REPORT OF PMRB ON THE FIELD VERIFICATION OF THE

APPLIED QUARRY AREAS OF EDNA BALMES, FERNANDO

TORRES, AND NESTOR SALES

REPORT ON THE FIELD VERIFICATION OF THE APPLIED QUARRY AREAS OF BALMES, TORRES, AND SALES

Photo 1. Satellite image showing suitable and recommended sites for sand and gravel extraction/quarrying activities

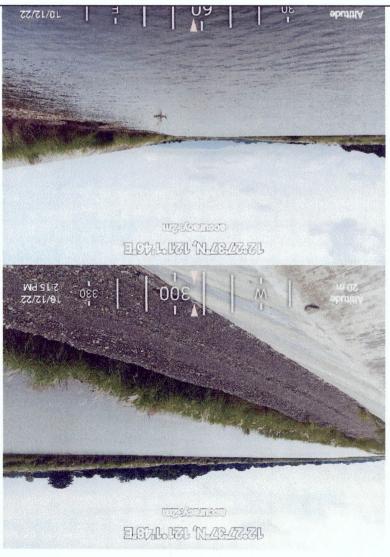
- c. During the assessment of the river segment near the proposed site, it was noted that water levels ranged from approximately 0.70m (red validation points within the river channel shown on the attached map) to more or less 1m towards the northwestern boundary of the applied area, in the central portion of the active channel. This particular segment is devoid of any sand/gravel bar deposits that are suitable and recommended for extraction/quarrying activities. (Please see the

attached satellite image – Photo 1 – of recommended quarrying sites). Riverbed deposits observed below the water table are consist mostly of cobble-sized sediments.
